Statement of Basis Approval of No Further Action Volume 7 of 30 January 2000, ER Site 72, Operable Unit 1333 Round 5

**ER Site 72
Operable Unit 1333
Round 5**

RSI Originally Submitted May 1998

OU 1333***ER Site 72, Operation Beaver Site***

Figure 1-1
Location of ER Site 72, Operation Beaver Site

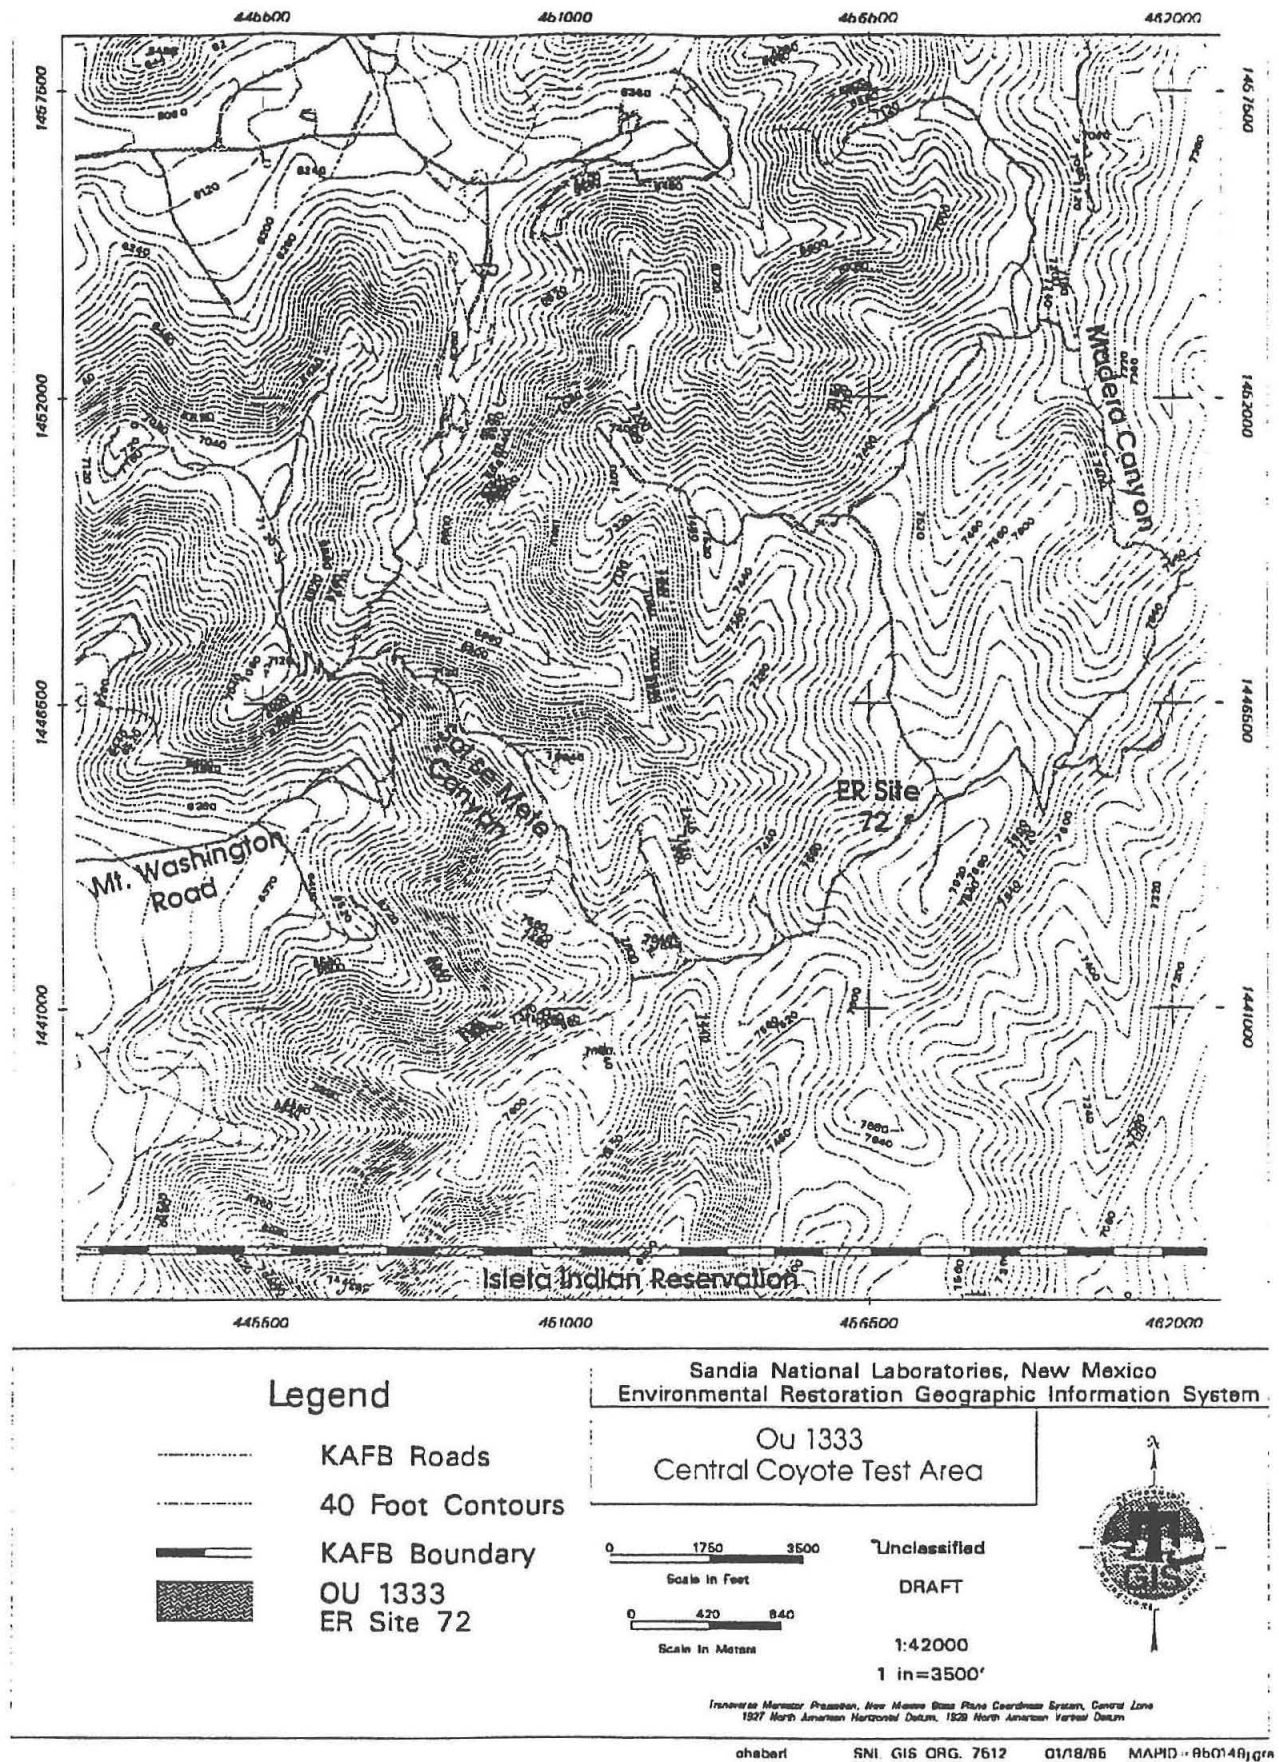
ER Site 72 is appropriate for NFA petition, pending submittal of a final site map (Figure 1-1) (see general comment 1).

Response: A final site map, Figure 1-1, is included in Attachment A of the General Comments section of this submittal. Please also refer to the response to General Comment 1.
